Ref. ID ADHOC-D-26-02099
"Onset-Anchored Selective Computation for Resource-Constrained Vehicular Edge Networks"
(submitted as "Trustworthy Selective Computation for Resource-Constrained Vehicular Edge Networks"; retitled in this revision, see R3.7)

Response to Reviewers*

*For the manuscript, Ref. ID ADHOC-D-26-02099, "Onset-Anchored Selective Computation for Resource-Constrained Vehicular Edge Networks" (submitted as "Trustworthy Selective Computation for Resource-Constrained Vehicular Edge Networks").

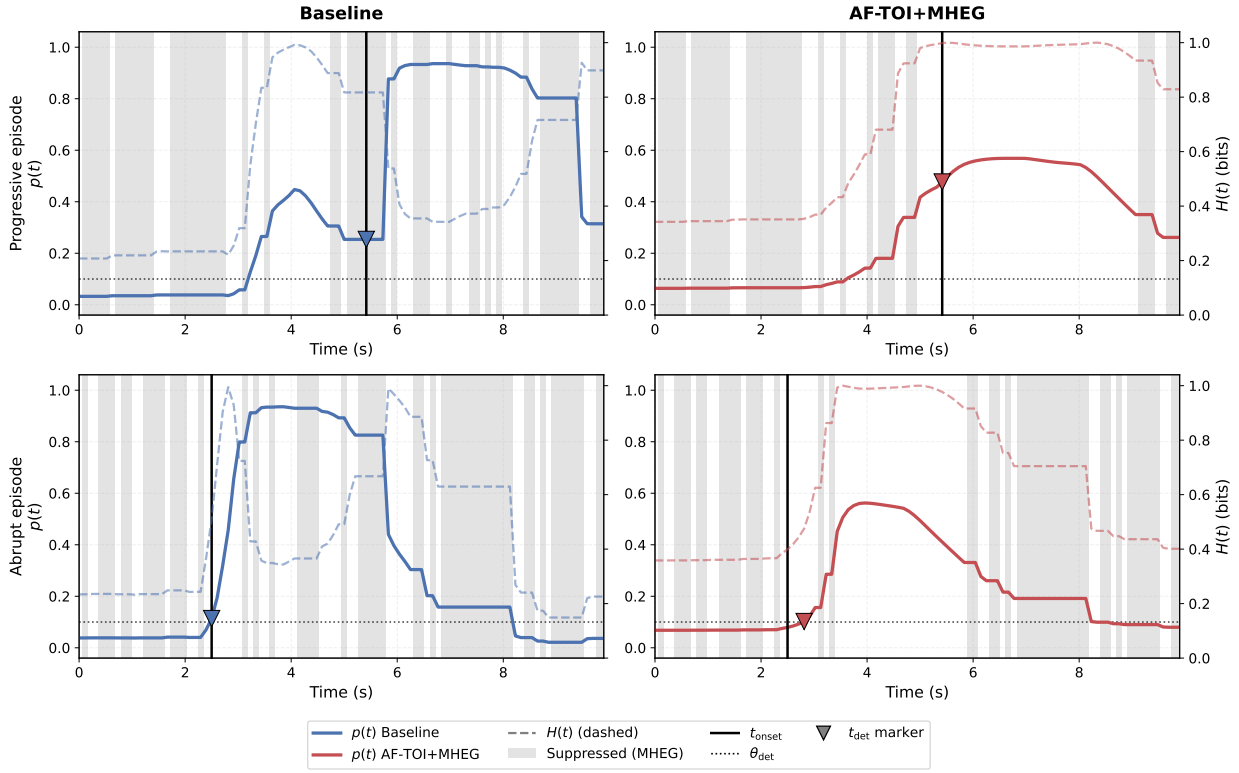
6. Comment: Frame-by-frame temporal evidence for seed 42 graph is not explained well.

Response: We agree with the reviewer. A frame-by-frame reading guide has been added to the paragraph following the first mention of Figure 5 in Section 4.2, identifying each visual element of the seed-42 examples. During revision verification we also found and corrected two problems in this figure, and we report them explicitly rather than silently: (a) the exemplar episodes of the submitted version were not selected by a stated criterion, and the abrupt exemplar was atypical (it belongs to a saturated minority of episodes whose entropy sits near the maximum throughout); the figure now uses, per regime, the episode with the *median* pre/post-onset entropy contrast among seed-42 critical episodes with central onset, and the caption states the criterion; (b) the replay that produced the suppression shading applied the entropy threshold in the wrong logarithm base (natural log instead of the base-2 entropy of Eq. 11), so the entropic branch of the gate never fired in that log; the log was regenerated with the correct base, and the entropy axes of Figures 4–6 are now uniformly

in bits, matching Eq. 11. The added text reads:

(The full frame-by-frame reading guide follows the first mention of Figure 5 in Section 4.2.) Its selection criterion reads: "The exemplars are selected by a pre-declared neutral criterion: within each regime, the episode whose pre/post-onset entropy contrast is the *median* among the critical episodes of seed 42 with a centrally located onset (progressive: episode 36, t_0=5.42 s; abrupt: episode 148, t_0=2.50 s)." The guide also states that detection markers of single exemplars do not arbitrate latency (aggregate latencies are settled by Table 8) and that a minority of abrupt critical episodes (12 of 48 in seed 42) runs near maximal entropy throughout. The regenerated figure is reproduced below.

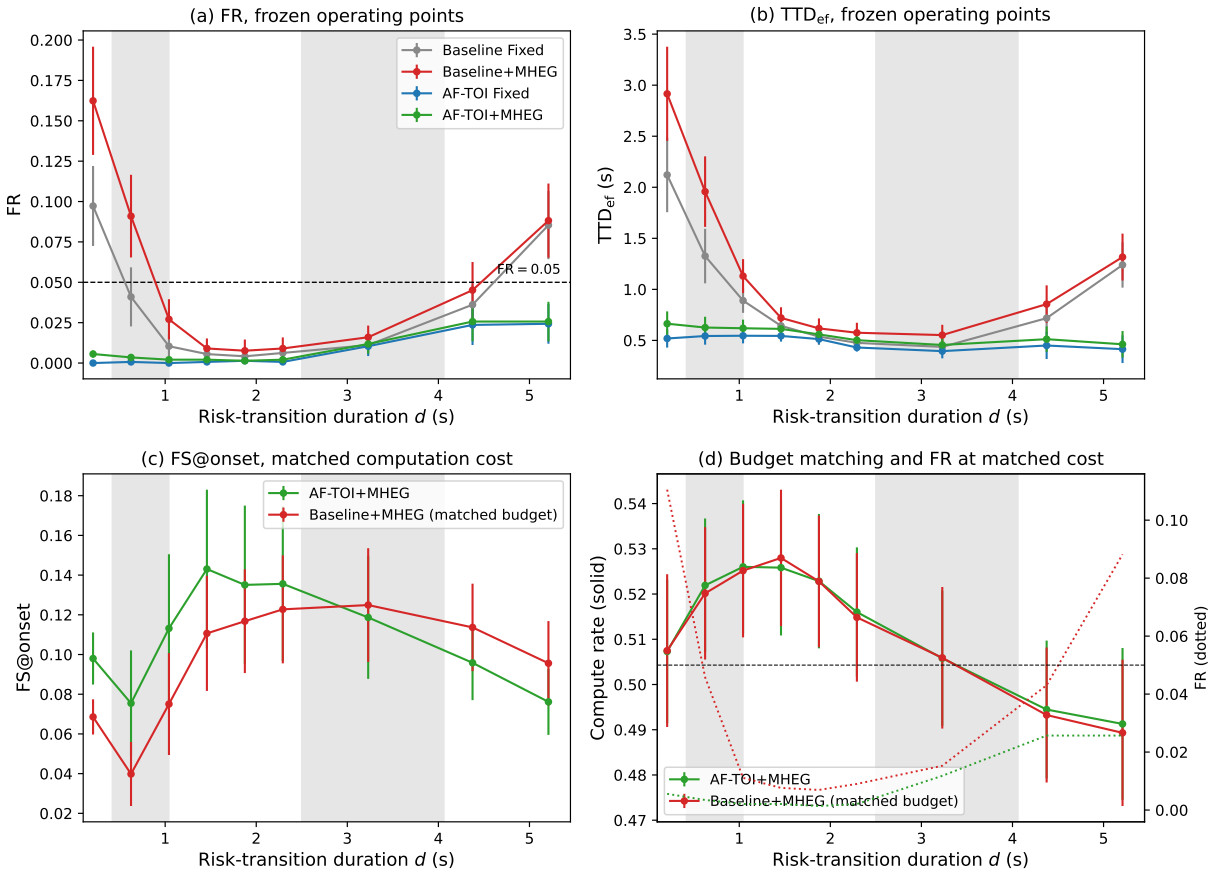
4. Comment: A central claim of the study is that temporal organization of uncertainty is important for safe selective computation, but the current experiments appear to be strongly tied to the risk-transition patterns defined by the experimental setup. The authors should investigate whether AF-TOI generalizes to unseen temporal risk trajectories, different onset durations, abrupt versus gradual transitions, intermediate-risk conditions, changes in the distribution of input features, or distribution shifts between training and testing conditions.

Response: We agree with the reviewer. To address the question of generalization across different transition durations, a new temporal-scale experiment has been added in Section 4.12, together with Figure 14 and Table 21. The experiment varies the risk-transition duration independently through a shape-preserving temporal warp while keeping t_0, the normalized transition shape, the episode context, the model weights, and the scheduler thresholds fixed. The limitations paragraph of Section 5 was also revised to distinguish this controlled temporal train–test shift from broader naturalistic distribution shift. The six aspects raised in the comment are addressed as follows.

The new Section 4.12 (Figure 14, Table 21) reads:

(The full design paragraph – shape-preserving temporal warp, measured duration d, frozen weights and thresholds of the twelve seeds, nine durations from 0.21 to 5.21 s with in-distribution anchors, an interpolation gap, and extrapolation extremes, and the zero-error reproduction anchor at the native duration – opens Section 4.12.) Its closing scale note reads: "The $\mathrm{TTD}_{\mathrm{ef}}$ magnitudes below are on this campaign's own scale – frame-level detection from the label onset on warped episodes – and are not comparable to the $\mathrm{TTD}_{\mathrm{ef}}$ of Table 8, which uses the original episodes and the main-campaign pipeline (Table 23); the zero-error anchor concerns reproduction of the campaign artifacts, not a shared metric scale."

"Figure 14a–b and Table 21 report the frozen operating points. AF-TOI maintains mean FR below 0.05 at every evaluated duration (maximum duration-wise mean 0.026), and $\mathrm{TTD}_{\mathrm{ef}}$ stays within approximately 0.40–0.66 s. The Baseline crosses mean FR = 0.05 at both extrapolation extremes (mean FR 0.097 at 0.21 s and 0.085 at 5.21 s for the fixed policy), and its $\mathrm{TTD}_{\mathrm{ef}}$ follows a U-shaped profile that reaches 2.12 s at the fast extreme. At the level of individual seed×duration cells, AF-TOI exceeds FR = 0.05 in 7 of 108 cells (all at $d \geq 3.23$ s, maximum 0.108), against 22 of 108 for the fixed Baseline (maximum 0.250) and 32 of 108 for Baseline+MHEG (maximum 0.333). Frame-level F1 remained seed-sensitive under the warp, a pattern consistent with checkpoint-level variability rather than with an effect of the warp itself. Accordingly, the result is restricted to aggregate coverage and effective delay and does not constitute a per-seed guarantee: AF-TOI shows aggregate temporal-scale robustness across the evaluated synthetic range of unseen risk-transition durations." (Section 4.12, second paragraph)

"Because the two frozen gates suppress different fractions of frames, we added a post-hoc matched-budget diagnostic: for each seed×duration cell, the entropy threshold of Baseline+MHEG was adjusted by bisection (...) until its computation rate (fraction of executed window updates; both arms share the recompute semantics of Section 3.4) matched that of AF-TOI+MHEG on the same cell (all 108 cells matched within 1.9%, tolerance 2%; Figure 14d). (...) At matched computation cost, no systematic FS@onset advantage remains (...). Under Holm correction within each endpoint family, only the $\mathrm{TTD}_{\mathrm{ef}}$ difference at 0.21 s remains significant ($p = 0.031$), so these per-duration matched-cost contrasts should be read as exploratory. The matched-budget diagnostic supports a temporal-scale coverage-and-timeliness advantage, not a universal improvement in near-onset suppression placement." (Section 4.12, third paragraph)

The new figure and table are reproduced below.
